5. Masterplan Massing, Scale & Layout

5.1. Masterplan Evolution

MASTERPLAN MASSING, SCALE & LAYOUT

JANUARY 2021 MASTERPLAN

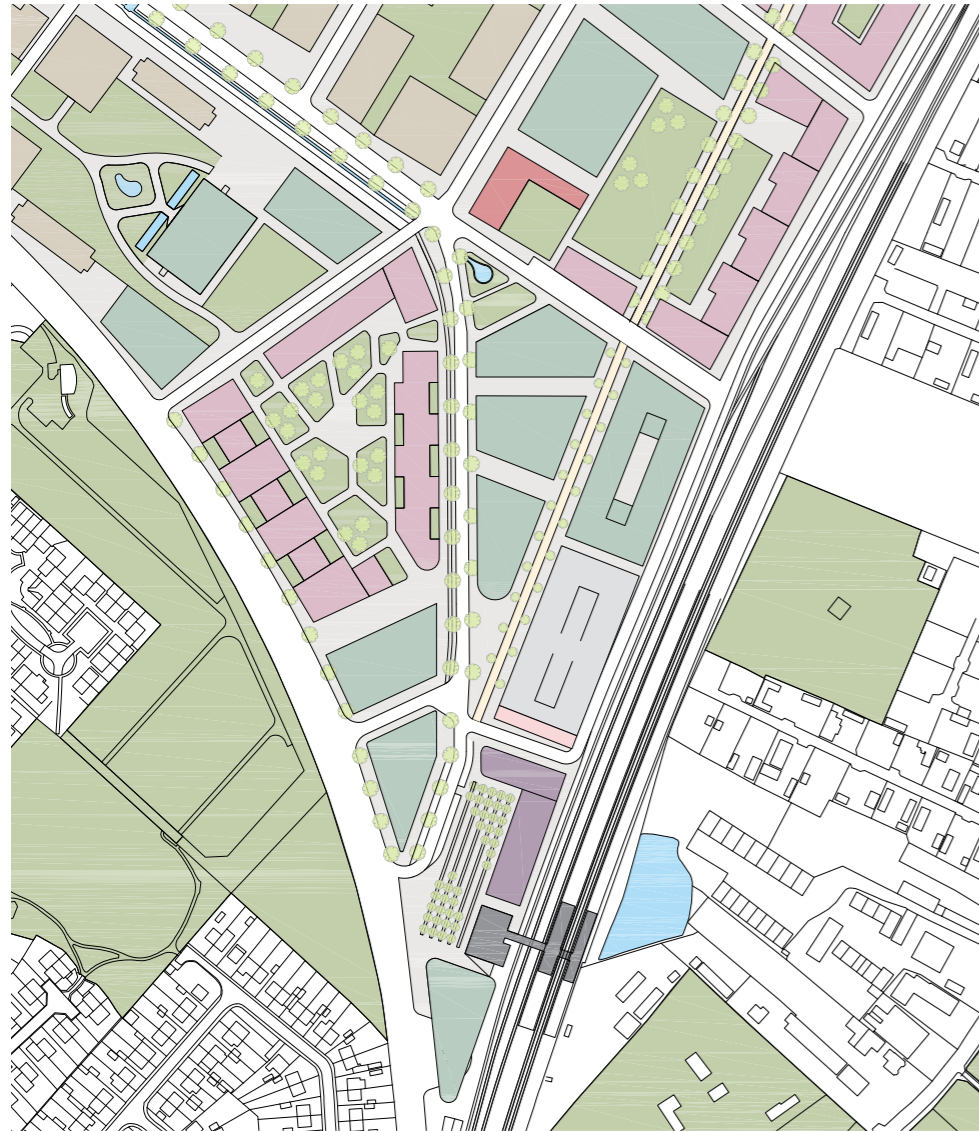
(-) The scale of residential development, comprising wholly 1 and 2 bed build to rent apartments is an area of concern.(...) At this stage we have not seen evidence of supporting uses to serve the needs of new residents travelling beyond the local area to access services and facilities. Further consideration of this and evidence of access to services and facilities needs to be provided.

- (-) The proposals are at quite an advanced stage with detailed plans which is a cause for concern because it is important for the LPA to have sufficient opportunity to influence the scheme.

- (+) Blocks R5 to R7 define an edge to Milton Avenue. This edge is required to create the envisaged 'avenue' and is supported.
- (+) A gap is retained to allow for future connection with the Business Park. This is also supported.

- (+) Blocks R3 and R4 present shorter return elevations to the Guided Busway and cycle route – this is acceptable.
- (-) However, there is a concern that the layout of the blocks does not relate sufficiently to the streets and spaces that are created.(...) Gaps between building are generally too big, awkwardly shaped, or not positioned in the right location when considering pedestrian flows and desire lines. It is felt that an urban block style approach could deliver a better overall development form.

- (-) The space “leaks” away to the east and west. Although connected with the Guided Busway, there are no significant desire lines through this space that would help to activate it. Also, there are no main entrances off this space as Block 03 and R4 are accessed from Milton Avenue and The Park respectively.

- (-) To the north of the site, the corners of block R1 and R7 have been “squared-off”. This results in “left-over” spaces and a poor sense of place.
- (-) Block R3 prevents a direct link between the Guided Busway / cycle route and the Cowley Road / Milton Avenue junction (known as “the Knuckle”) via The Park.

- (-) Further attention needs to be given to how R1 and the proposed space at “Milton Square” relates to Building R9 and the adjoining maths college. Strong links and relations, both physically and visually need to be created (...)

- (+) Step back from the more detailed plans produced to review overall shape/ massing and placement of residential blocks.
- (+) Step back from the more detailed plans produced to review overall shape/ massing and placement of residential blocks.

- (+) Edge to Milton Avenue adopted in latest masterplan proposal.
- (+) Future connection with Business Park adopted in latest masterplan proposal.
- (+) Buildings along this edge articulated to emphasize shorter returns.

- (+) Residential footprint has been reconfigured, with the road running through the central open space rerouted along the periphery. This allows for the creation of a meaningfully large and distinct open green space with a clear function as a residential courtyard.

- (+) Blocks re-configured to enhance the sense of enclosure whilst allowing for clear sight lines for key routes surrounding the building blocks.
- (+) Building footprints have been redesigned to minimize awkward angles.

- (+) A clear vehicular and cyclist route was created along the northern edge of the residential blocks, creating a strong direct link.
- (+) The open space has been reshaped to create clear sight- and desire lines as well as connections from the residential plots across to commercial square at knuckle and beyond to the open spaces north of the scheme.

JANUARY 2021 MASTERPLAN

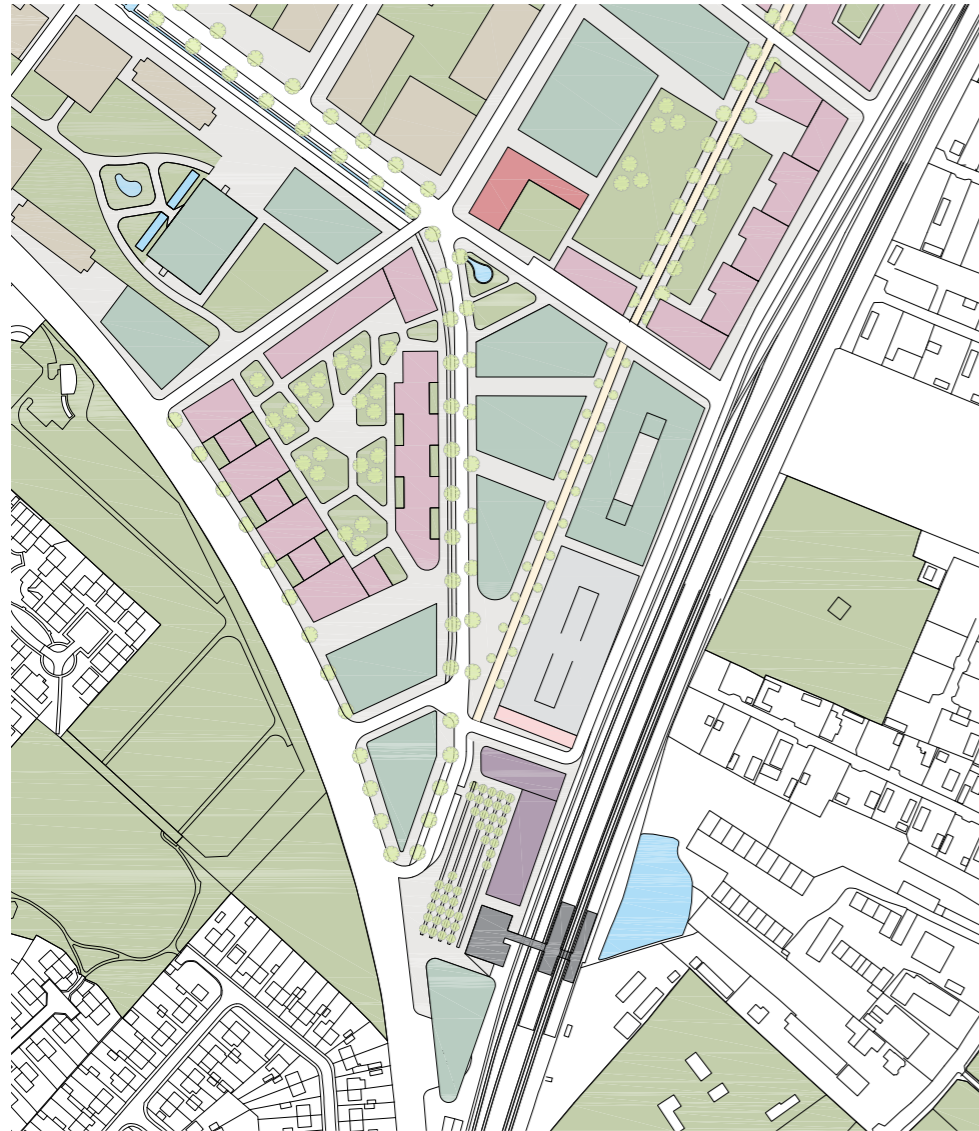
- (-) It is therefore not considered that the heights of the buildings reflect that set out in the AAP and to suggest that it does is somewhat disingenuous.

- (-) The LVIA which was said to be currently in the early stages, should be used to inform the design, including the height and massing of the development. This interrogation has not yet been completed.

- (-) The accepted character of Cambridge is one of low-level development, dominated by trees in most cases with occasional incursion of tall buildings/spires etc. The proposed mono-height proposals of 8+ storeys is not in keeping with this characteristic and potentially creating a large monolithic development of the sort that Policy 60 is in place to avoid.

- (-) There is a concern that the scale of the buildings will overwhelm the size of the streets and spaces provided.
- (-) Articulation of building height, ridge lines, building lines, window designs and corners is considered essential in creating both a more undulated and less "slab-like" sky line, and providing a human scale at street level.

- (-) A key concern of the proposed elevation designs relates to the lack of articulation and the impact (or lack thereof) on the sense of scale and massing of the building as set out above.

- (-) The design of the blocks within each parcel are too repetitive, whereas on the other hand there is a lack of "dialogue" / connection between the parcels.

- (-) Buildings are generally designed to be symmetrical and rather formal - even though the spaces they address are not.
- (-) Because the uniformity in design of individual buildings, they fail to respond to specific features of the site layout.

- (-) There are also serious concerns about the treatment of the ground floor, in particular where the blocks address The Park.
- (-) Materiality and colour need to be carefully co-ordinated between the parcels. This should consider the setting of the street / square / park, as well as the designing of individual buildings.

- (-) Public art was not discussed at the meeting however this should be included in the proposal at an early stage.

- (+) Heights have been reviewed and lowered to better reflect the emerging NEC AAP suggested building heights.
- (+) LVIA study pending.
- (+) The residential block design has been reviewed and are now being articulated in height to allow for height variation across the scheme and avoid mono-height proposals.

- (+) Hierarchy of open spaces and streets have been studied to shape the scale of development and adopt a more human scale to the scheme.
- (+) The building heights have been reduced and massings further articulated to create a more human scale to the overall development.

- (+) The residential blocks along the eastern and western edge have been significantly articulated and stepped in plan to reduce the overall visual impact and minimize the perception of long and flat elevations.

- (+) Different typologies have been adopted across the Masterplan to provide variation in block and unit types.
- (+) Blocks have primarily been reshaped alongside character areas and open spaces, so all blocks respond to the varying open spaces across the site.

- (+) Open spaces have been shaped and carefully placed at regular intervals to curate the overall ground floor experience and activation.
- (+) Design guidelines will be created to help shape the character and visual identities of all buildings within the scheme.

- (+) A public art consultant will be appointed to work with the design team on an public art strategy.

JANUARY 2021 MASTERPLAN

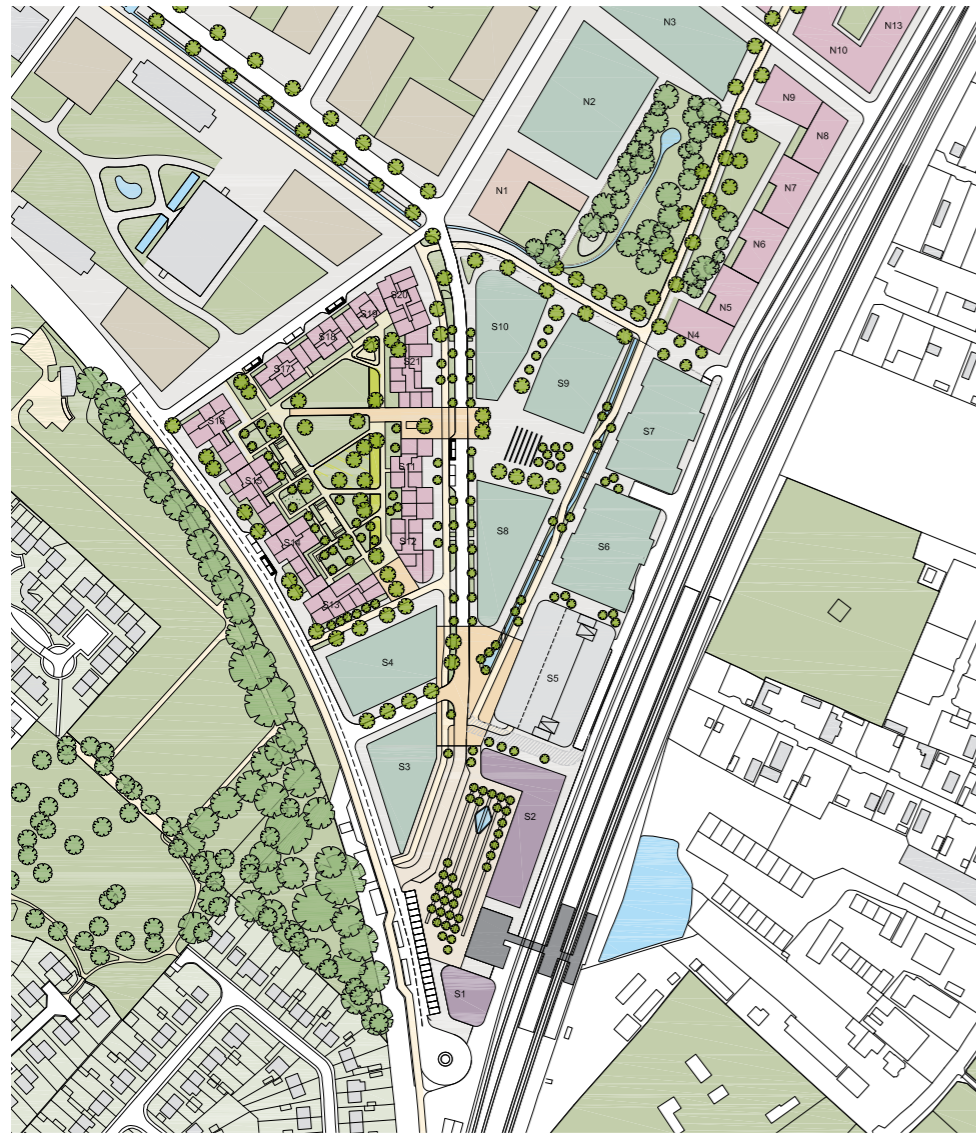
(-) Although all the dwellings meet the Nationally Described Space Standards, many units are single aspect units, some of which are very deep, also many will receive limited light due to orientation and the sitting and height of adjacent buildings.

(-) There is also a concern about the large number of units served of a single core.

(-) Open Spaces are not particularly clear in their intention. Areas such as 'The Slice' were described by officers as 'gappy' which is in reference to a lack of legibility of whom or what the space serves.

(-) It is understood that the passage of vehicles will be low but due to the nature of the site as a residential development access will be very variable.

(-) The key 'marker' area within the site is actually the small diamond shaped paved square in the part of the site devoted to the maths building.(...) The paved square will be difficult to understand from ground level and will be seen as a group of trees.

(-) There are concerns that the SUDs strategy may incorporate the majority of the space which may impact on the quality and usability of the open space.

(-) Pedestrian and cycle links need to be identified and connected with. The community will have limited access to facilities within the site so must have efficient and convenient access to cycle and pedestrian routes beyond the site.

(-) There is a significant under provision of open space within the proposals and this is not justified

(-) There are concerns that the students will use areas outside the school in the local area which could result in anti-social behaviour.

(-) There will undoubtedly be families living in the units therefore a more considered play strategy is required.

(-) There should be some provision for allotments/community gardens which are suitably accessible for all residents.

(+) Large open space adjacent to and adjoining the eastern edge of the school can serve as spill-out space to which students can have access to.

(+) Residential blocks have been broken down and reduced in heights to reduce the number of units serving each core with the exception of the landmark tower.

(+) Overall footprints have been reconfigured around a hierarchy of open spaces and roads to give each buildings a clear function.

(+) Vehicular routes have been rerouted where possible to the edge of the scheme to create car free open spaces dedicated to pedestrians and cyclists.

(+) Open spaces have been reconfigured in order to create clear sightlines across key open spaces within the wider scheme.

(+) A key clear dedicated north south pedestrian and cyclist spine has been created along the eastern plots allowing for a connection to the future developments north of the station. All plots have been shaped respecting distinct desire lines and pedestrian routes.

(+) Larger more meaningful open spaces have been created for the Residential Quarter.

(+) Management strategies for public realm and open spaces will be explored at a later date to mitigate anti-social behaviour.

(+) Larger and vehicle free open space has been provided for the Residential Quarter allowing for more play space.

(+) Allotments can be placed on roof terraces and open space to cater the needs of local residents.

APRIL 2021 MASTERPLAN

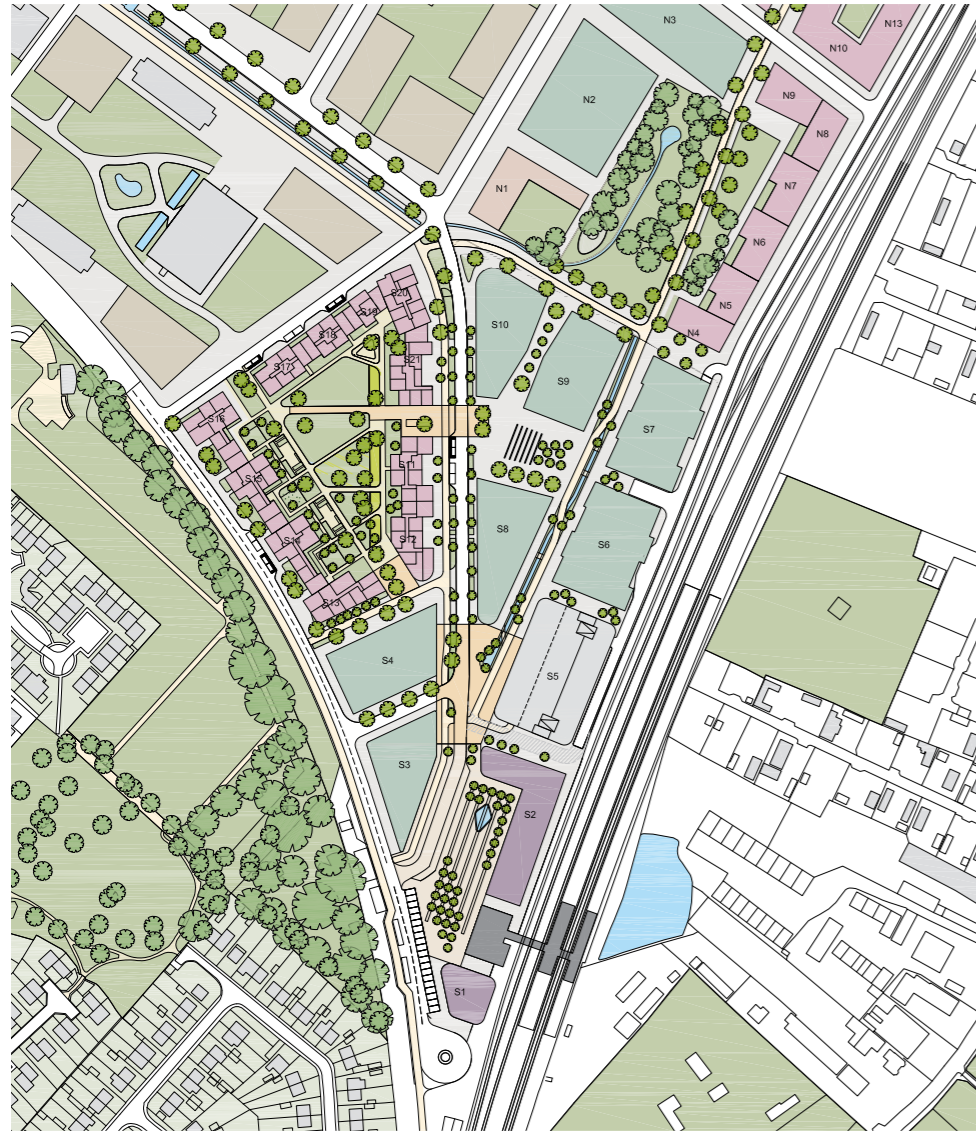
- (-) By bringing forward the application ahead of the AAP (...) in the short to medium term, and possibly indefinitely, this development would need to deal with 'bad neighbours' and relative isolation (...) This is of particular concern in relation to the maths school and residential component of proposal.
- (-) Serious concerns that the PRS scheme as proposed in Phase 1 would not deliver enough critical mass and diversity to establish a cohesive and sustainable community.
- (-) The scheme appears to be residential led, or at least not employment led contrary to policy SS/4
- (-) The open space in new developments SPD outlines expectations primarily in residential developments. It is fairly clear that the proposals will fall below the required open space requirements.

- (+) The masterplan introduces a north south pedestrian and cycle spine (...) Access to car parking serving future developments would be redirected from Cowley road to the back of the development (...) It is agreed that these proposals will have a positive impact on the quality of the environment.
- (-) There are concerns about the impact on Cowley Road, will there be sufficient levels of movement retained on Cowley Road to ensure it will be a safe and vibrant thoroughfare.

- (+) Proposals demonstrate a street based approach to masterplanning with a clear distinction between front and backs, public and semi public spaces. This results in a clearly defined and legible network of streets and spaces which is welcomed.
- (+) Illustrative material presented show the experience of moving through the streets and spaces has been carefully considered and is commended,
- (-) Will acme be retained as 'supervisors' to coordinate the next stages of design?

- (+) Residential unit mix and layout designed to create an enclosed community with shared open and amenity space within courtyard, to allow scheme to work independently and in anticipation of additional future development.

- (+) Math School to be brought forward with later developments to prevent isolation.
- (+) Detailed study into program and quantum examined to create cohesive community undertaken.

- (+) Planning Application outline extended to include open space north of commercial quarter to fulfil open space requirement.
- (+) Principle has been adopted and retained in the latest masterplan proposal.

- (+) Commercial blocks reconfigured to create commercial square, allowing pedestrian spine porosity from Milton Avenue.
- (+) Ground floor spaces identified along Milton Avenue to ensure continued significance.

- (+) Principle has been adopted and retained in the latest masterplan proposal.
- (+) Principle has been adopted and retained in the latest masterplan proposal.

- (+) Acme has been appointed as lead architects to oversee the Masterplan and coordinate forthcoming stages of the design.

JUNE 2021 MASTERPLAN

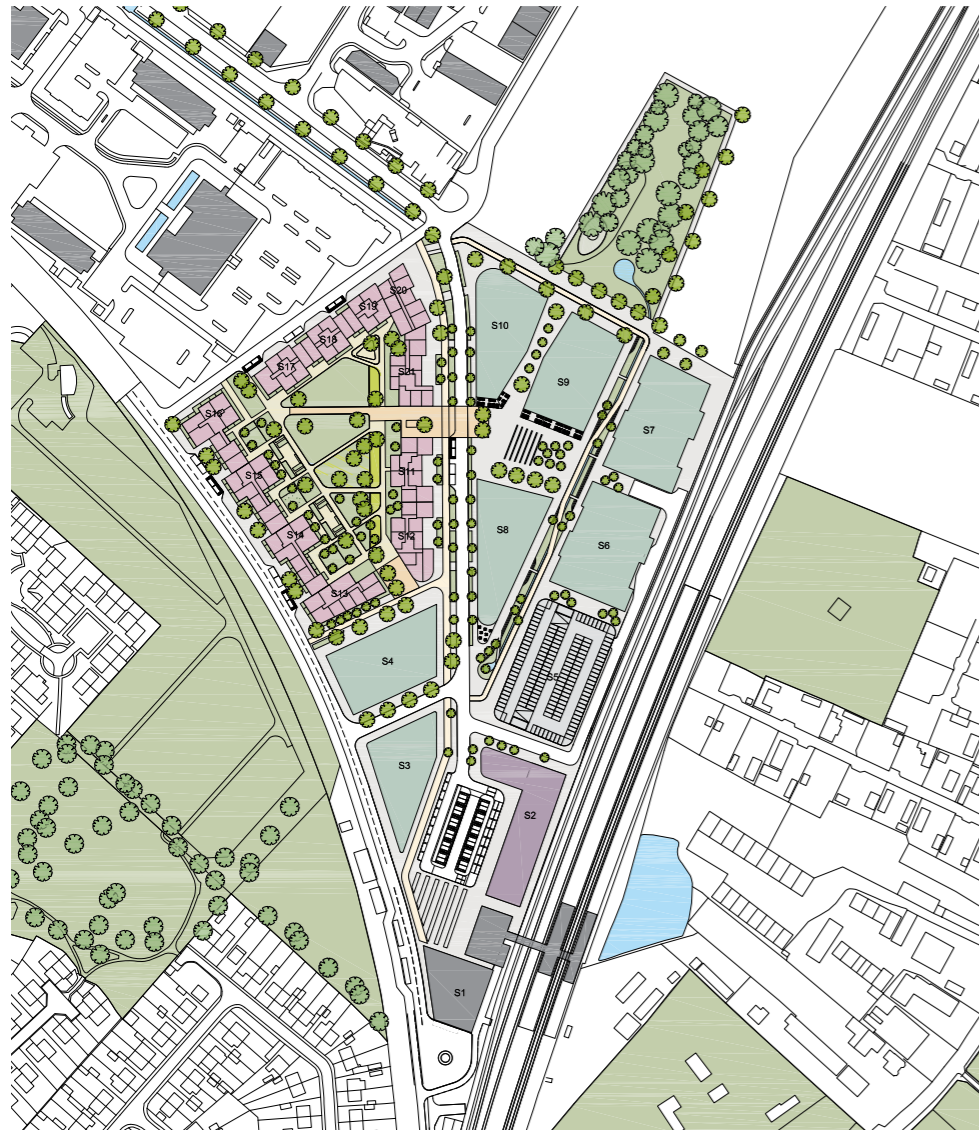
- (-) A robust marketing report would need to be submitted to demonstrate how the scheme would meet local need and demand
- (-) We also have concerns that the only affordable housing to be provided on this development will be as affordable private rent.
- (-) A scheme comprising 49% one bed units and 45% two bed units does not represent a mixed community
- (-) Due to the high density housing in close proximity to the train station, particularly due to county lines concerns, consultation with the police is an important part of the pre-app process

- (-) Further work needs to be done to demonstrate impact on Milton Plaza of a car barn access across this space
- (-) It is unclear if (pedestrian, outdoor seating and a Swale) can all be accommodated in an 18m wide street.
- (+) Special treatment at the key crossing points around Central Square and Milton Plaza is supported
- (-) Pedestrian movement from station square at the residential development needs further consideration.
- (+) Adjustment of S4 ground floor plan is supported but needs to be explored in further detail

- (+) The proposal demonstrates a street-based approach to masterplanning (...). This results in a clearly defined and legible network of street and spaces which is welcomed.
- (+) Spacing between blocks S5,S6 and S7,S89 and S10 are acceptable, further to sufficient day light access into office buildings.

- (-) The most significant element required, the LVIA is needed in order to begin making decisions about height, massing and placement of features and this work is still outstanding.
- (-) Significant reservations with the scale and mass of the buildings on the edges (...) taller than the maximum identified in Figure 21 of NEC AAP Draft.

(+)The marketing report has been undertaken and is pending completion.

(+) Percentage of overall 3 bedroom units increased to approximately 13% in order to provide greater diversity.

(+) Traffic consultants have assessed and confirmed that access is feasible.

(+) Sections provided to illustrate distribution and use.

(+) Principle has been adopted and retained in latest masterplan design proposal.

(+) Additional 3D view studies carried out to show pedestrian experience throughout scheme.

(+) Principle has been adopted and retained in the latest masterplan, a slit has been made over a double height allowing for greater porosity.

(+) Principle has been adopted and retained in the latest masterplan.

(+) Principle has been adopted and retained in the latest masterplan.

(+) LVIA study commissioned and pending.

+ Overall heights adjusted in line with the draft NEC AAP. Building height of S20 reduced to 8 storeys.
